Permit of Authorization to Construct an On-Site Sewage Facility Permit Valid For One Year From Date Issued

Permit Number: 115953
Issued This Date: 03/23/2023
This permit is hereby given to: STEPHANIE M. & CHRISTOPHER R. HENNEY

1393 PHANTOM RIDER TRL
SPRING BRANCH, TX 78070

**Re: Stephanie M. & Christopher R. Henney
Cypress Springs on the Guadalupe Unit 4 Lot 273
Application for Permit for Authorization to Construct an On-Site
Sewage Facility (OSSF)**

OWNER: STEPHANIE M. & CHRISTOPHER R. HENNEY		DRAWN BY: EJS III	
STREET ADDRESS: 1393 PHANTOM RIDER TRAIL			
LEGAL DESC: CYPRESS SPRINGS on the GUADALUPE	UNIT/SECTION/PHASE: 4	BLOCK:	LOT: 273
PREPARED BY: GREG W. JOHNSON, P.E. F#002585	SCALE: 1"=50'	DATE: 2/28/2023	REVISED: 3/23/2023

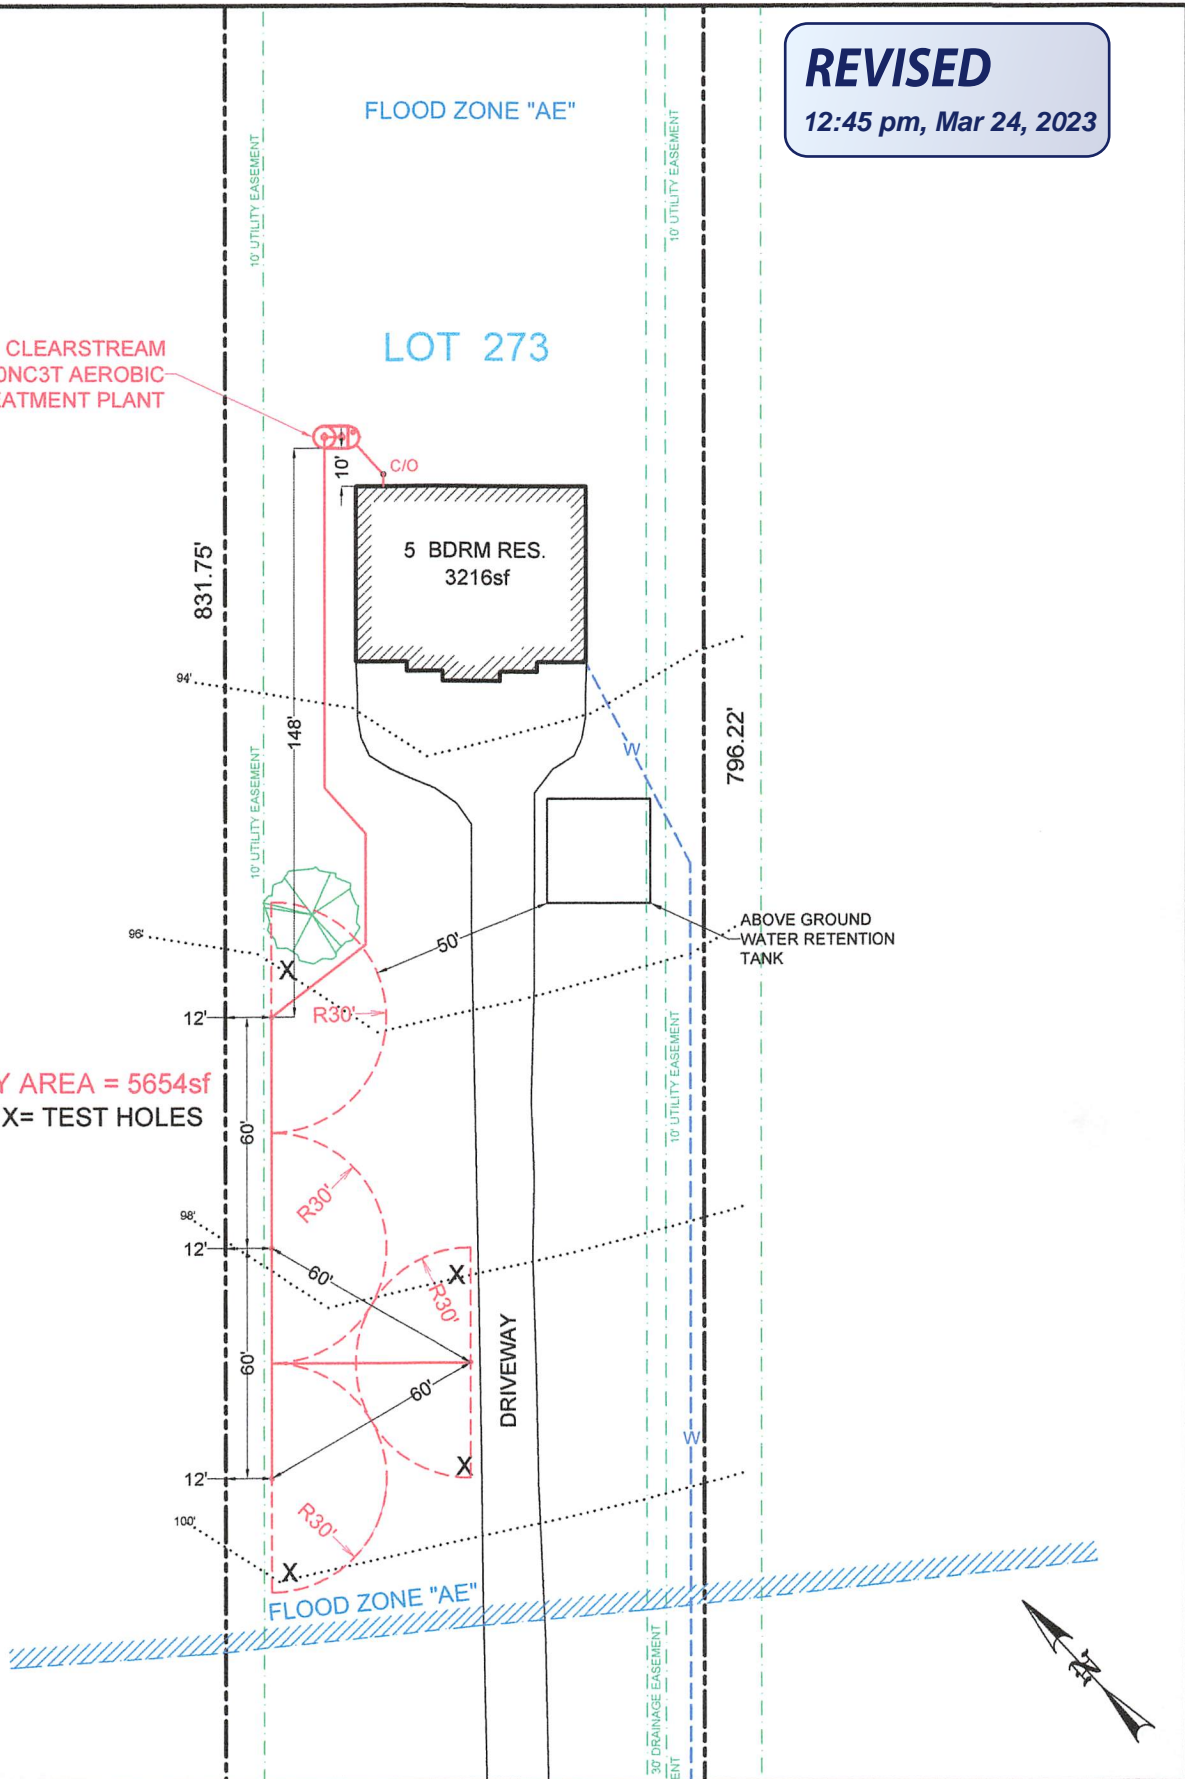
Due to the lack of available application area it is necessary to have the setback from the property line to the spray at ten feet as required by TCEQ Chapter 285 rules Table X. I hereby request a variance to the twenty foot setback to property lines as required by Comal County Order and equivalent protection will be maintained by including a battery backup to the timer clock to assure sprayers to only spray during the predawn hours. In my professional opinion this variance will not pose a threat to the environment or public health.

OWNER:	STEPHANIE M. & CHRISTOPHER R. HENNEY			DRAWN BY:	EJS III
STREET ADDRESS:	1393 PHANTOM RIDER TRAIL				
LEGAL DESC:	CYPRESS SPRINGS on the GUADALUPE	UNIT/SECTION/PHASE:	4	BLOCK:	LOT: 273
PREPARED BY:	GREG W. JOHNSON, P.E. F#002585	SCALE:	1"=50'	DATE:	2/28/2023
				REVISED:	3/7/2023

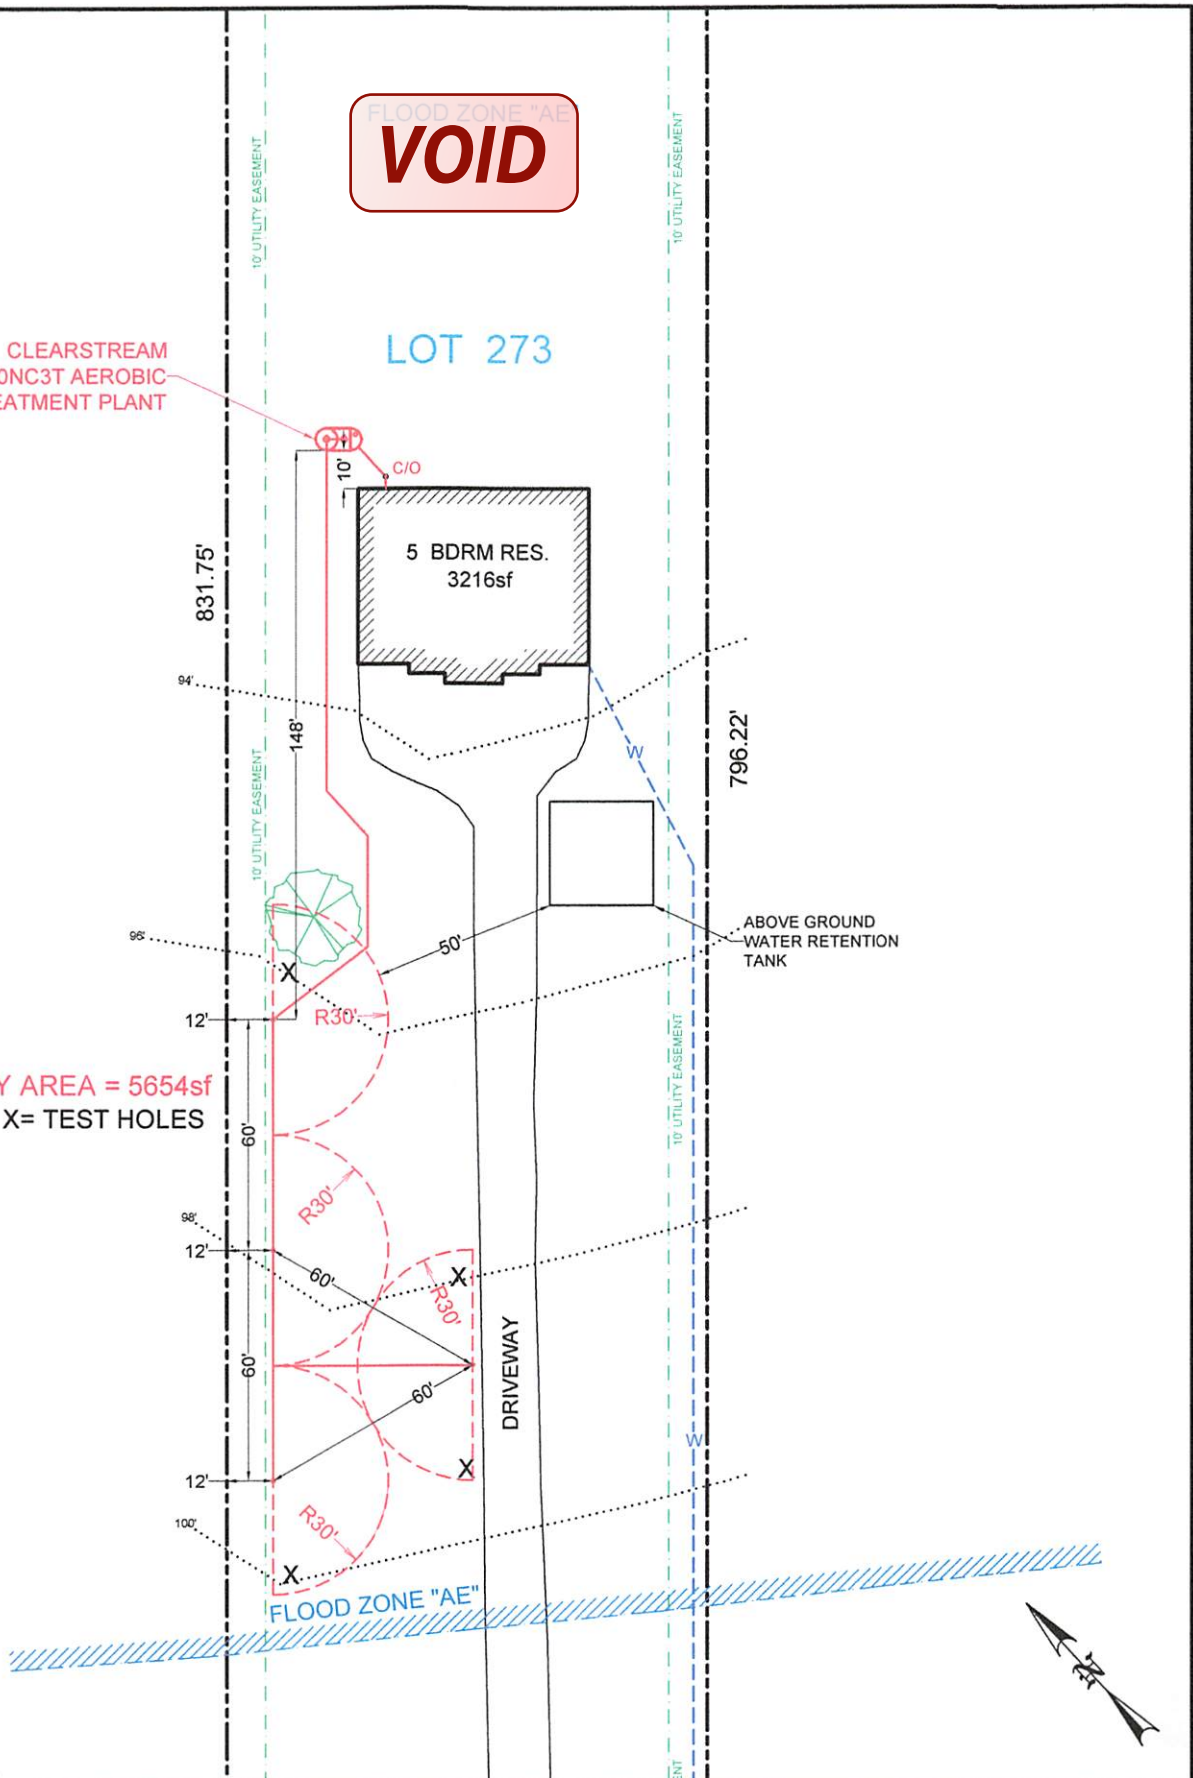
- ✓ 1. Show the drainage easement on the design (see attached copy of the plat).
2. Revise as needed and resubmit.
